**Response to EPA Information Request
OCI Beaumont LLC
Greenhouse Gas PSD Application**

On behalf of OCI Beaumont LLC (OCI), this document is submitted to respond to the GHG PSD permit application completeness determination dated July 25, 2013. OCI is responding to these questions in the same order. For ease of review, the EPA questions are duplicated here with the OCI response following each question.

NSR Permit #901 - Block Flow Diagram
De-Bottleneck Project, 3rd Qtr 2014

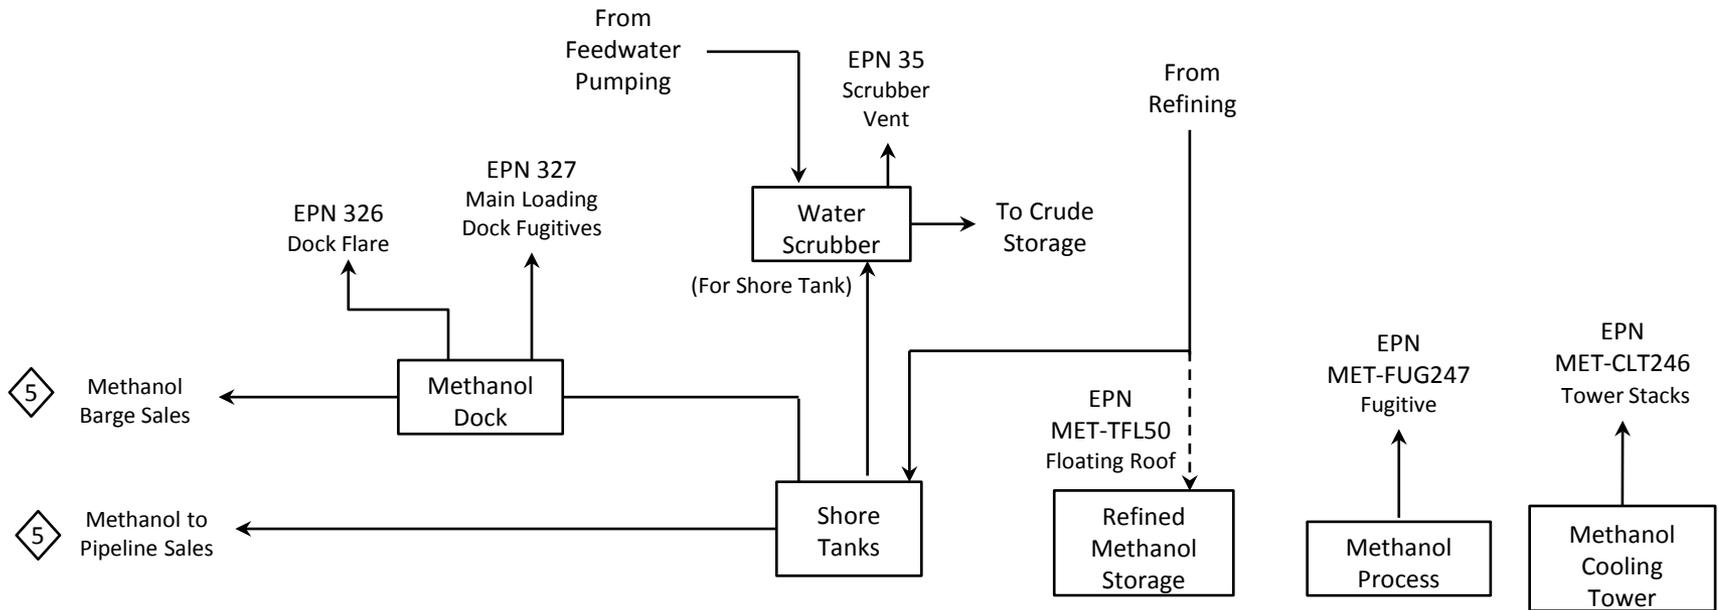
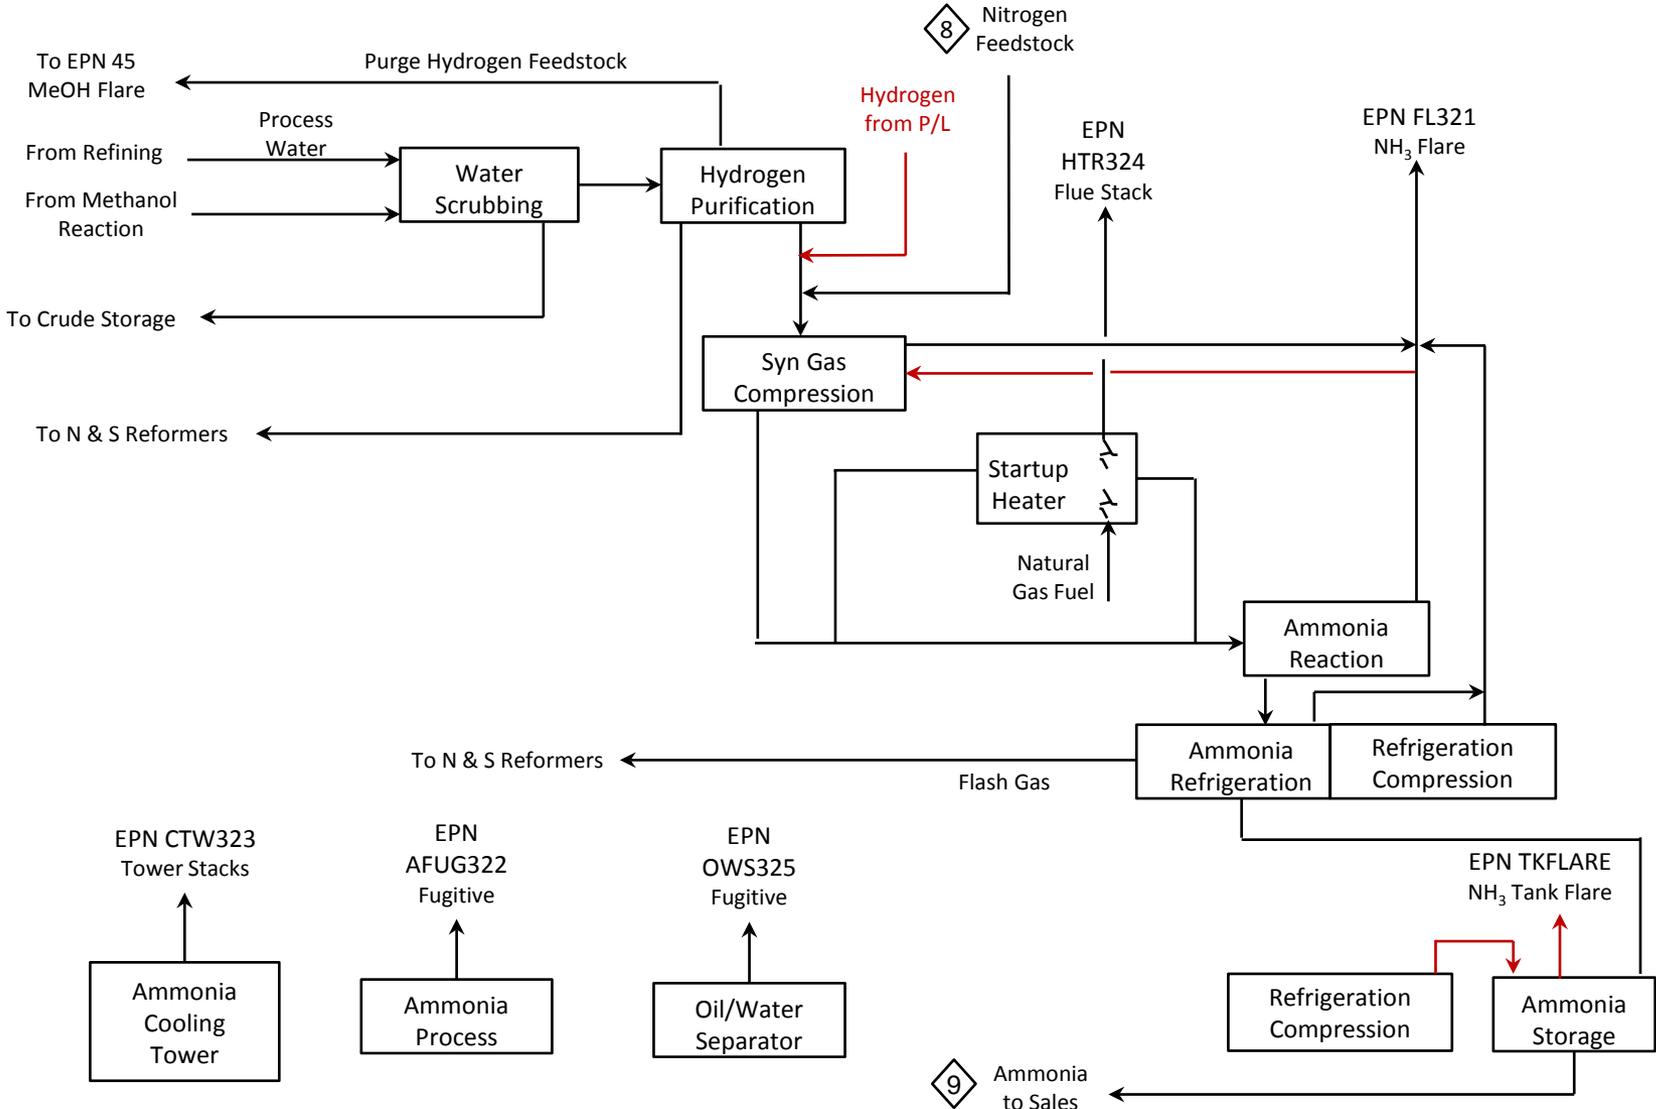
1. On page 1-1 of the permit application, it is stated that the Methanol Plant's capacity will be increased by the addition of a Pre-Reformer, Pre-Reformer Fired Heater, Saturator Column and a new flare to control MSS emissions from the reformer vent during emission events, startups, and shutdowns. It is also stated in the BACT analysis that OCI Beaumont (OCI) proposes a reformer tube replacement. The "OCI Process Energy Efficiency Improvement Study", located in the Appendix of the application, states that the existing reformer tubes will be replaced with larger diameter and thinner walled thickness tubes. It is important that all new, modified and affected (existing non-modified emission points where emissions will increase) units and emission points are properly identified on the process flow diagram. Will there be piping modifications to accommodate the increased methanol and/or ammonia production? If so, please identify on the process flow diagram.

2. In addition to the previous comment, please supplement the OCI process flow diagram with the following information. It is suggested that OCI consider enhancing or revising the process flow diagram to distinguish the new, modified, and affected units or emission points.

OCI – There will be piping modifications due to addition of the new equipment. These component changes are addressed in the TCEQ permit application for this project. Attachment A to this response is a revised block flow diagram (BFD). The overall BFD is highlighted to indicate modified and new emission points. Detailed plant flow diagrams (PFDs) are included for the new and modified equipment to show more detail. Please note the detailed PFDs are considered confidential.

OCI – Please see our response to No. 1. Attachment A contains the revised BFD and PFDs.

DRAWN:	SCALE: NONE
DWG. NO. SK-03	REV. A

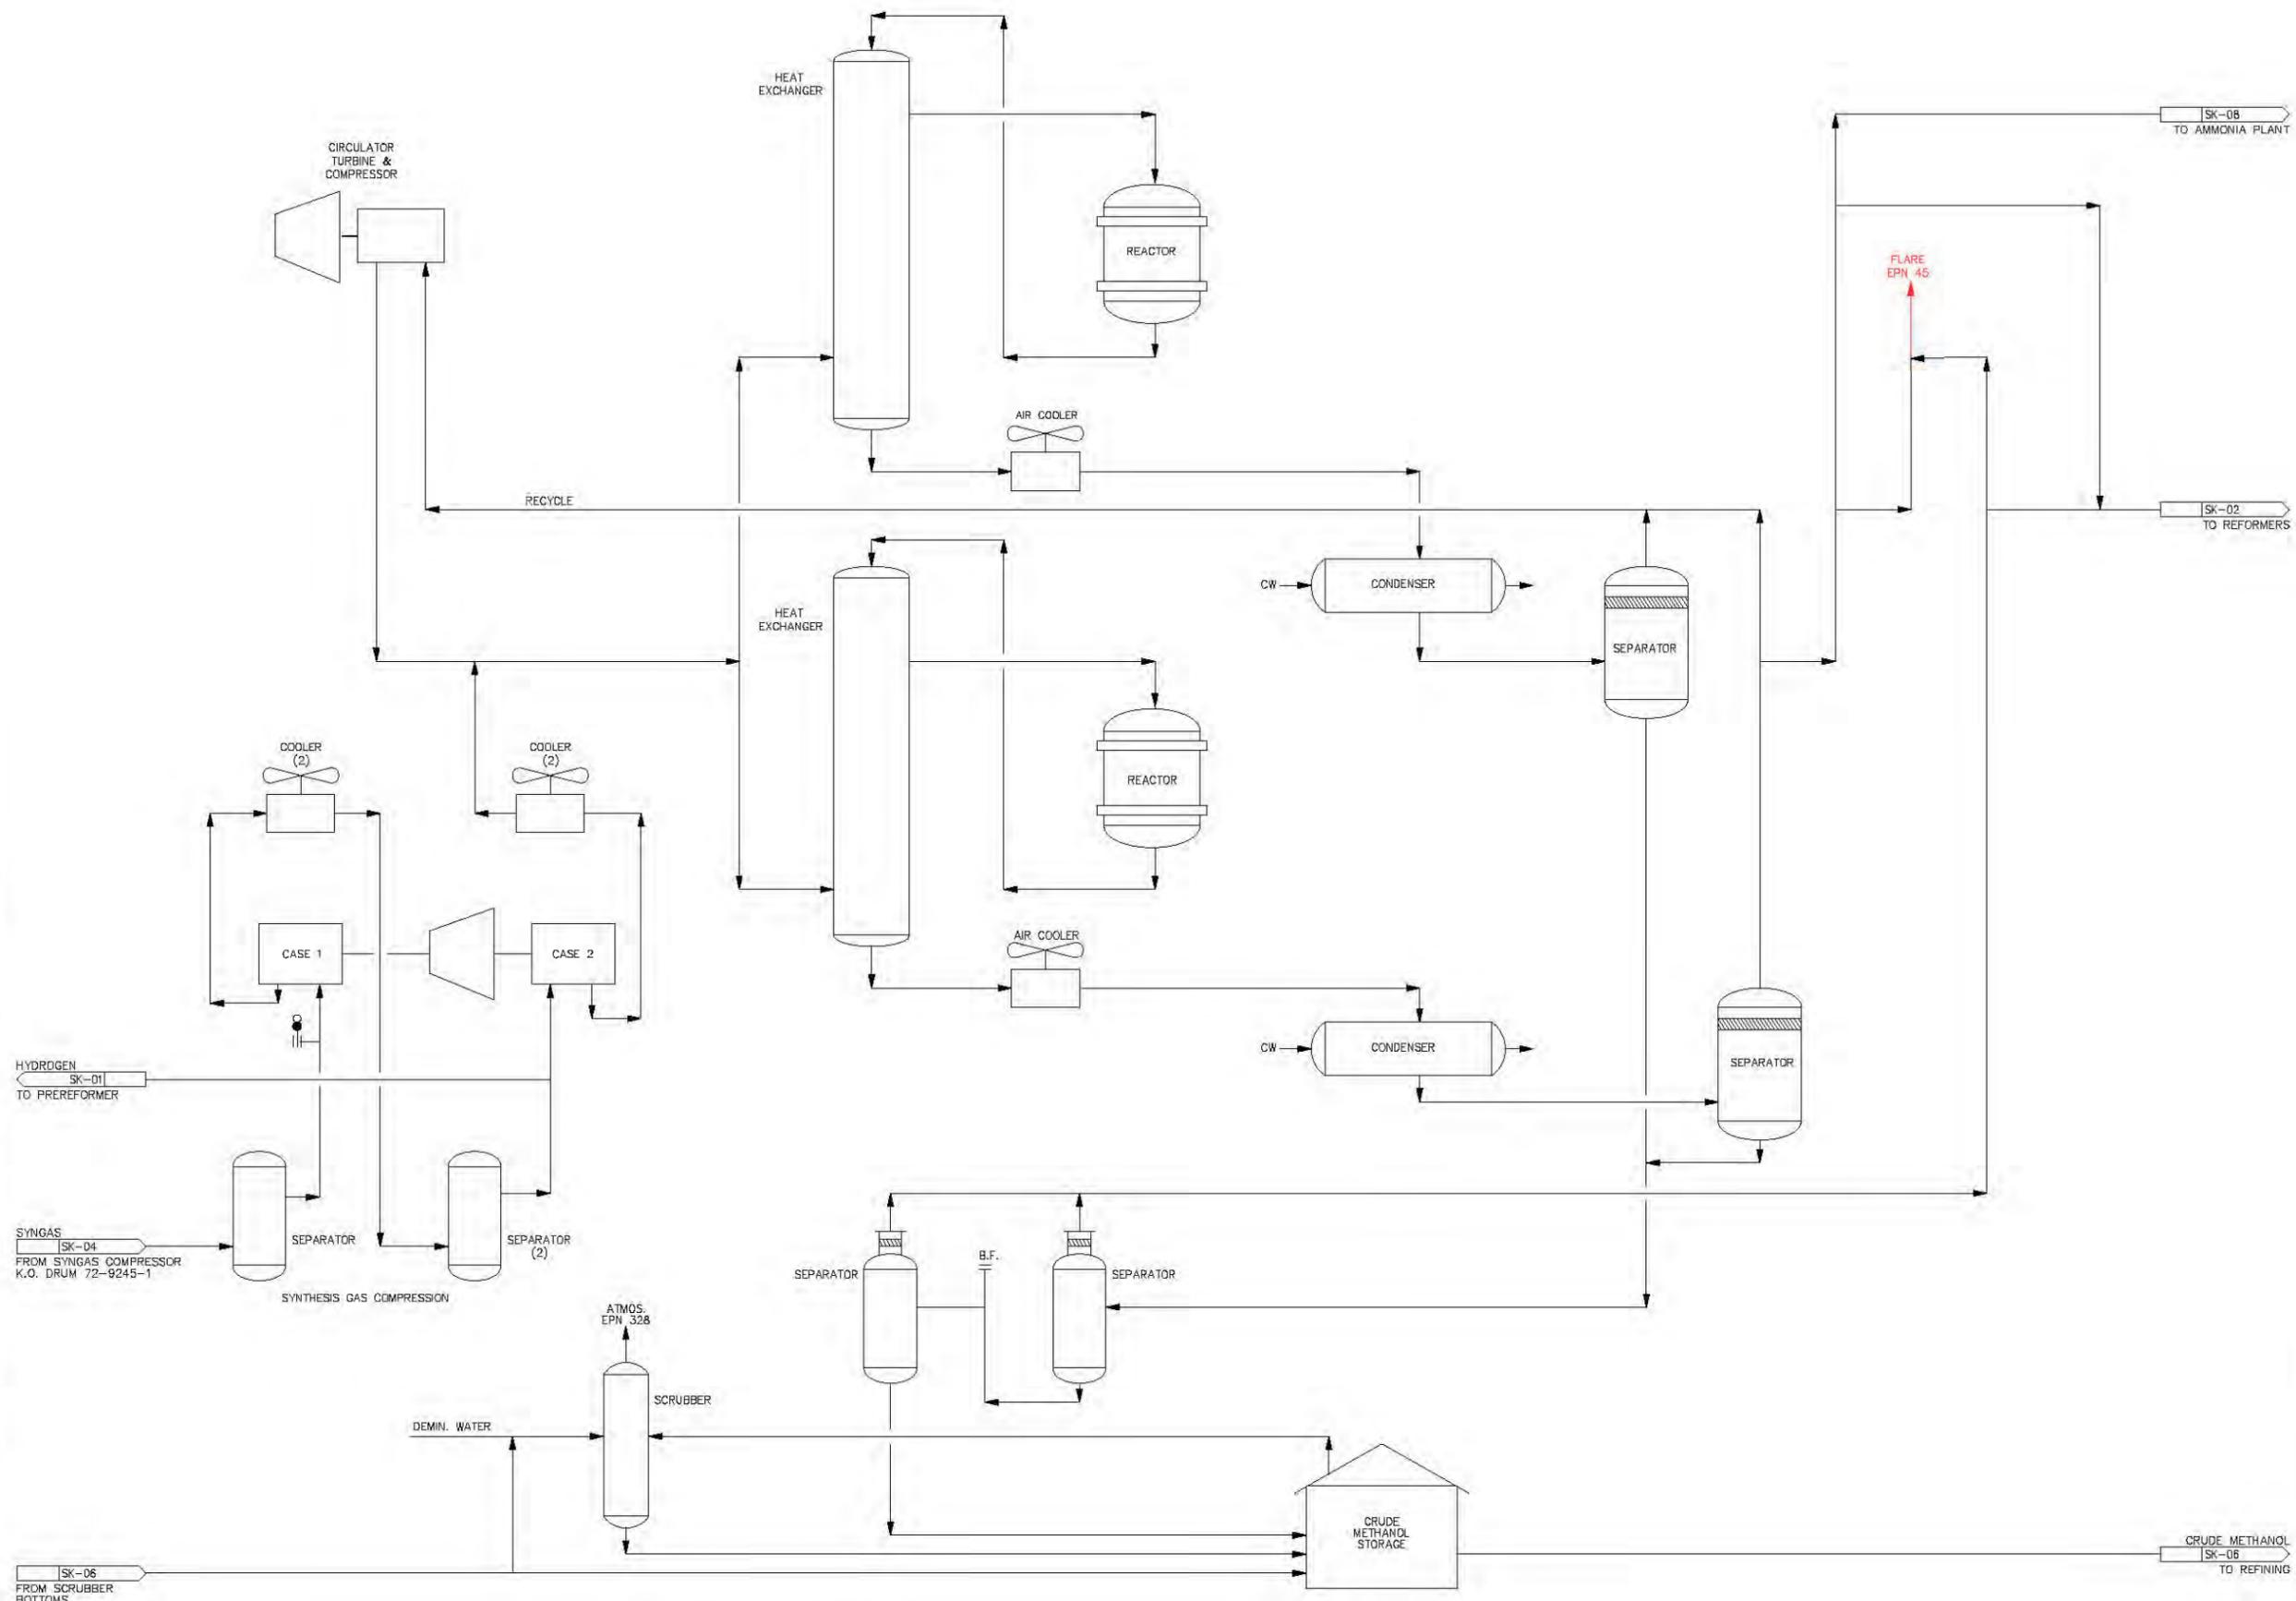
F. On page 3-2 of the permit application, it states the mixture leaving the reactors is cooled to separate the condensable liquid from the non-condensable gases using a water cooled heat exchanger. The water cooled heat exchanger does not appear to be shown on the process flow diagram. Please revise the process flow diagram to include this heat exchanger.

OCI – The BFD does not show it but PFD (SK-05), included in Attachment A, shows a water-cooled condenser, as the final cooler for each reactor train.
